SUBJECT: FY19 Joint Routine Inspection of Completed Works, Flood Risk Management Project, Genesee River and Dyke Creek, Wellsville, New York (09/23/19)

Flood Damage Reduction Segment / System
Inspection Report
Genesee River - Left Bank and Channel,

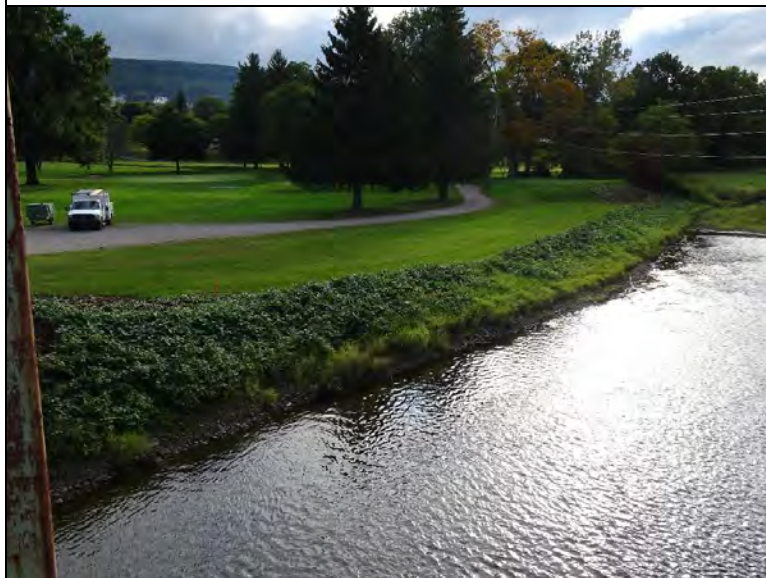
Inspect ID: N21L_2019_r_0019 **Title:** USACE_CELRB_N21L_2019_r_0019_1.jpg
Rated Item: 1. Vegetation and Obstructions **Caption:** Rating: Minimally Acceptable;
Remarks: Vegetation in excess of 12" on left bank of channel just downstream of golf course pedestrian bridge.; **Action:** Mow vegetation to 3"-6" height.; **Station_1:** 105+00;
Station_2: 104+00

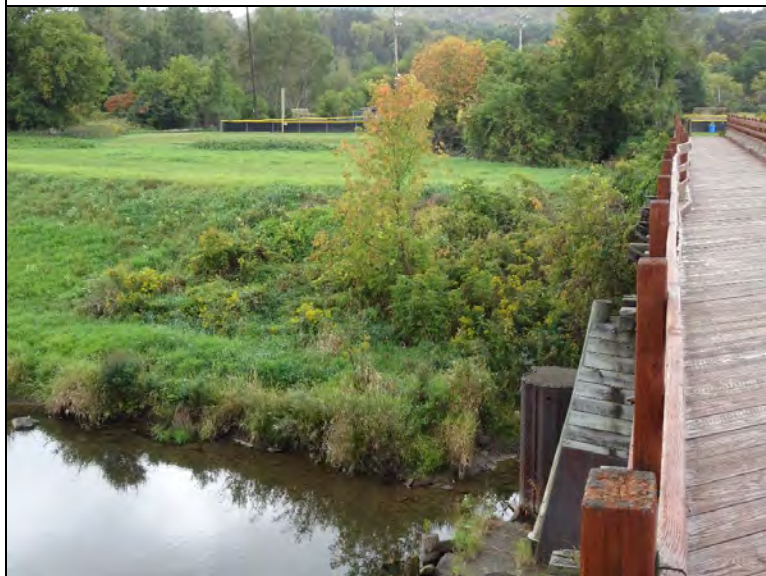
Inspect ID: N21L_2019_r_0006 **Title:** USACE_CELRB_N21L_2019_r_0006_1.jpg
Rated Item: 10. Riprap Revetments & Banks **Caption:** Rating: Minimally Acceptable;
Remarks: Woody vegetation in riprap on left bank from barrier levee weir to 550'
downstream.; **Action:** Remove woody vegetation from riprap.; **Station_1:** 6+00;
Station_2: 0+00

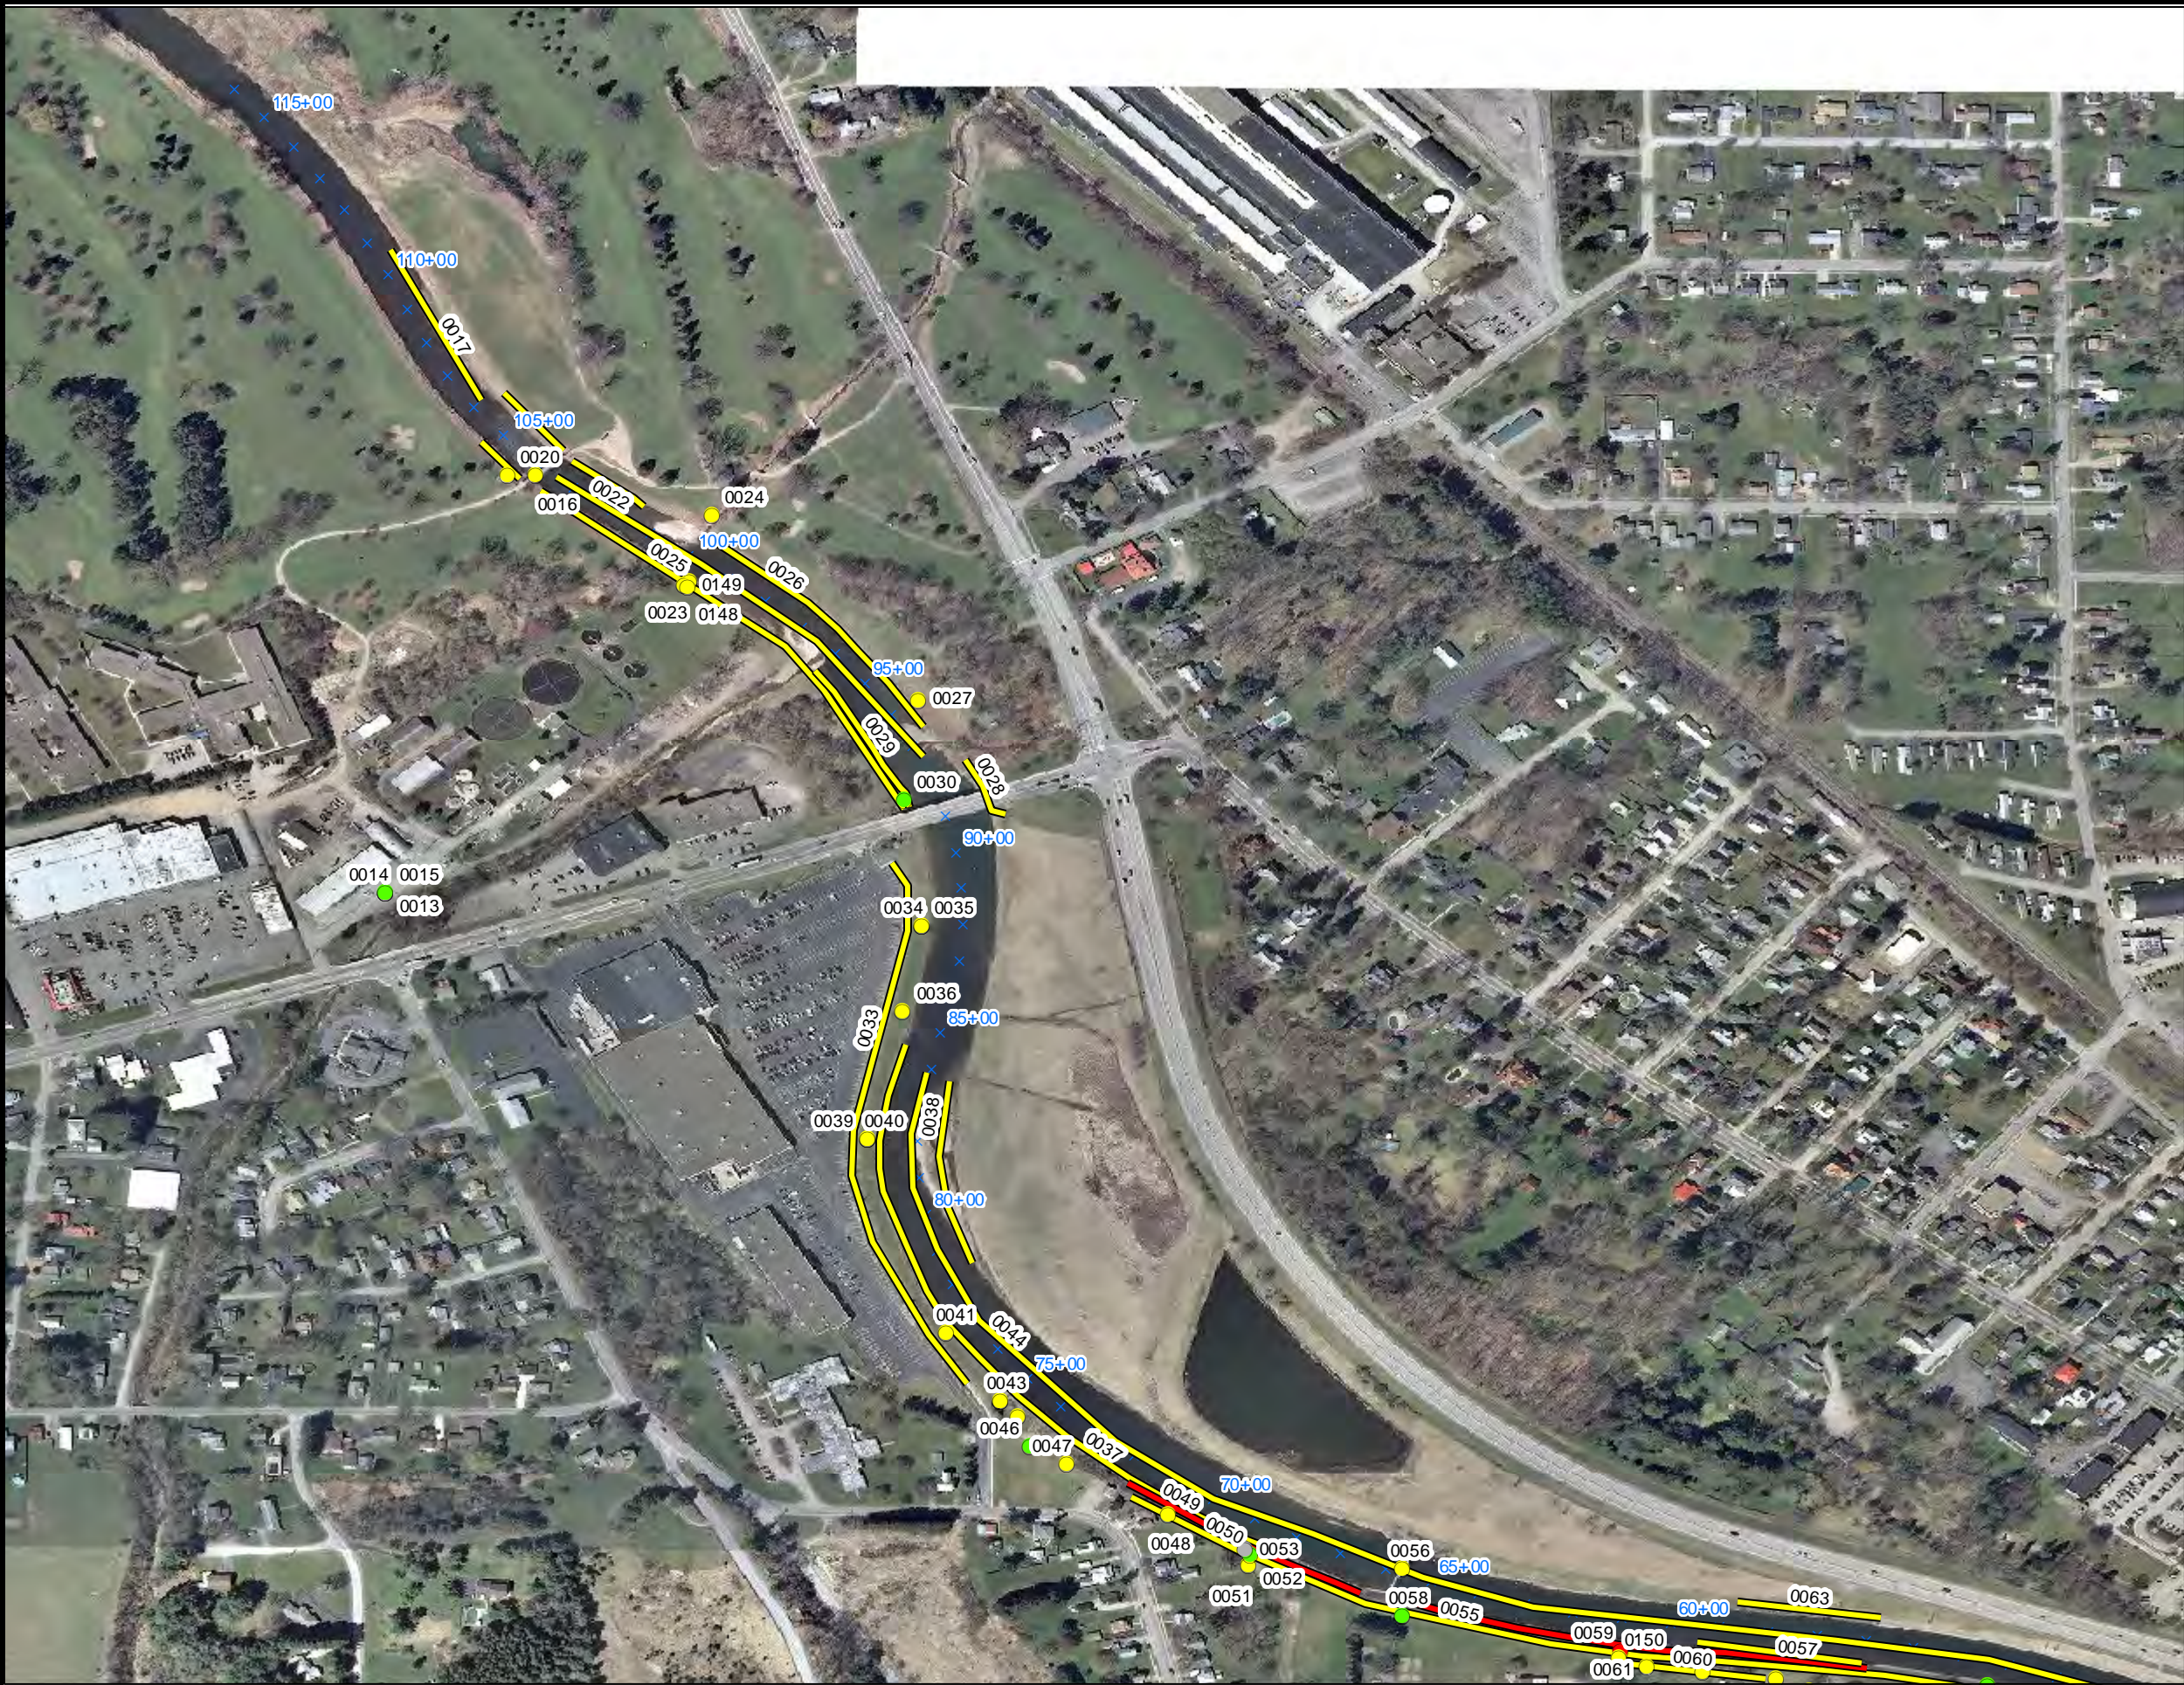
<p>Inspect ID: N21L_2019_r_0144 Title: USACE_CELRB_N21L_2019_r_0144_1.jpg Rated Item: 10. Riprap Revetments & Banks Caption: Rating: Unacceptable; Remarks: Trees and vegetation in riprap on right bank from upstream limit weir to 300' upstream.; Action: Remove trees and vegetation from riprap.; Station_1: 0+00; Station_2: 0+00</p>
